NUMBER: 03-82-18R

SERVICE INFORMATION BULLETIN

SUBJECT: Clutch Release (Throw-Out) Bearing-

Design Change

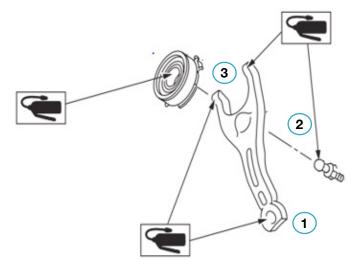
- To avoid customer concerns of a post-repair creaking, squeaking or clicking sound possibly accompanied by increased pedal effort (stiffness) when operating the clutch pedal, always thoroughly clean, inspect for signs of wear and re-lubricate the clutch release components. Any worn components identified should be replaced. For example: see the photos below which show excessive wear on areas of the release fork which was the root cause of a squeaking sound heard while the engine was running.
